OPINION

Preliminary Plan 120060420 (formerly 1-06042)
NAME OF PLAN: 8711 Georgia Avenue Office

TO: ELZA HISEL-MCCOY
FROM: JOSHUA SLOAN
SUBJECT: 8711 GEORGIA AVENUE SITE PLAN
DATE: 10/13/2008
CC: STUART BARR, LERCH EARLY & BREWER

Re: Stormwater Management **Revised CONCEPT**
Request for 8711 Georgia Avenue Assoc.
Preliminary Plan #: 120060420
SM File #: 215341
Tract Size/Zone: 0.76 Ac./CBD-2
Total Concept Area: 0.76 Ac.
Parcel(s): N107 and N109
Watershed: Lower Rock Creek

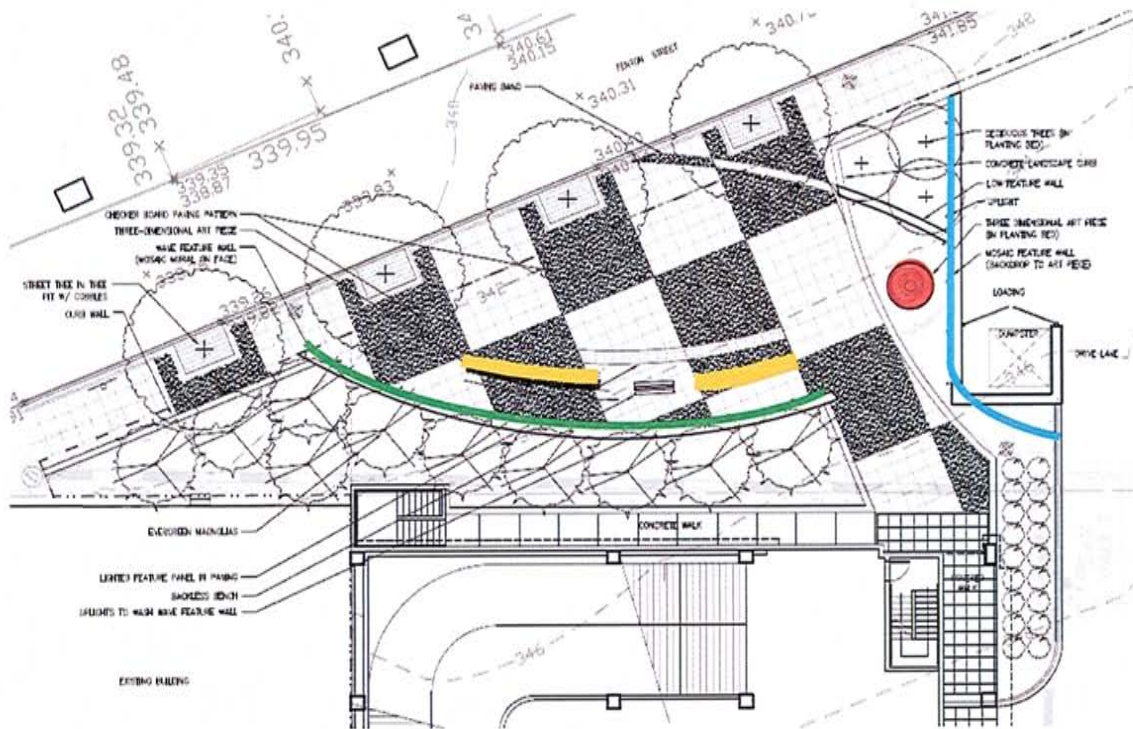
The plaza itself is an acute triangle – with Fenton Street acting as the hypotenuse. A grove of trees is planted between the building, which is a parking level at this grade, and the plaza. Another planting softens an eastern wall (blue arc in the illustration below) that screens the alley, dumpsters, and loading area from the plaza. This planting is lower except for a group of trees near the sidewalk and a small hedge along the alley. Fenton Street is planted with street trees similar to Georgia Avenue. The paving in the plaza and up to the curb is a diagonally set grid pattern placed at right angles to Fenton Street. Both planting areas are defined in contrast to this linear pattern by long sweeping curves. The curve along the grove of trees acts as a retaining wall and varies in height like a rolling sea (green arc in the illustration below).

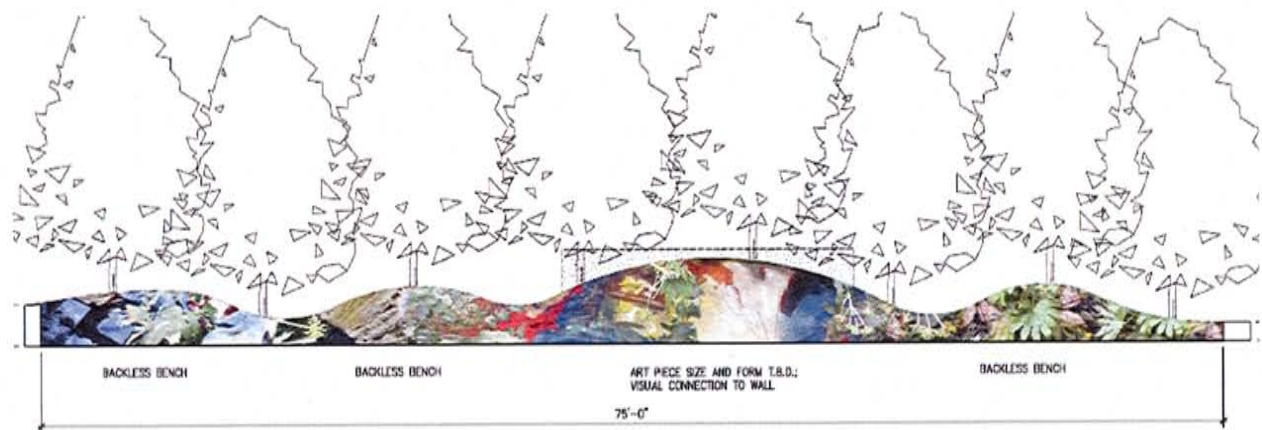
The curved wall that retains the grove of trees is one canvas that will become a mosaic piece. The lower eastern-side planting contains a free-standing mosaic piece (red circle in the illustration) and the wall that separates the alley from the plaza becomes another large canvas. In addition, two free-standing bench forms (yellow arcs in the illustration) sit within the plaza on either side of a bench and complement the curves of the retaining wall.

"Wave Wall" Concept

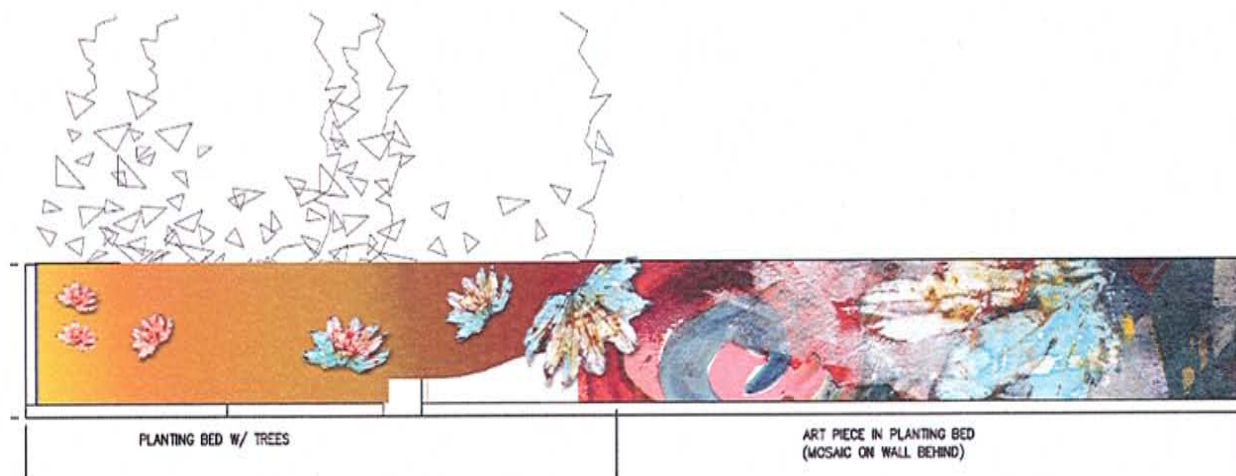
Early in the discussion, the Panel brought up the basic questions of how the space would be used and how the forms would read in the landscape. In this regard, the feeling was that the forms and patterns were too horizontal in their realization and the intimacy that is a goal of the design was lacking functionally. The artwork, it was felt, could be more three dimensional in its realization and possibly integrated more into seating areas that would achieve a setting for more intimate gathering. While it was agreed that the plaza may not act as a destination in and of itself, it could allow many people to move through while providing sitting at the periphery, more integrated into the landscape. Thus, the artist, could use the art to carve out spaces and relationships in concert with the plantings and paved spaces rather than being applied to the previously defined spaces.

The materials and design of the work, as with most of Ms. Jackson-Jarvis' work, was gorgeously conceived. The colors and materials are appropriate to the theme; the lighting, in particular, will bring out the translucent stone components and reflect off the tiled pieces to give the work a dynamic quality at night. To bring some of this dynamism and craftsmanship to the entire site, it was suggested that a smaller piece or other elements of the work be brought to the Georgia Avenue forecourt or entry area. Whether this is another free-standing piece or a wall-application was undetermined – the important point being the provision of a taste of the artwork and plaza at the rear of the site. In a related issue, the Panel felt it would be appropriate to maintain the diagonal paving grid along the alley sidewalk and through the front entry court to enhance the connection and continuity of the design concept.

During the site plan review process it is recommended that these observations and concerns about the lack of integration and interaction of the art with the overall space be taken into consideration. The Panel believes that substantial changes to the public amenities to address these issues, or others, should be presented to the Art Review Panel prior to approval of the Certified Site Plan.
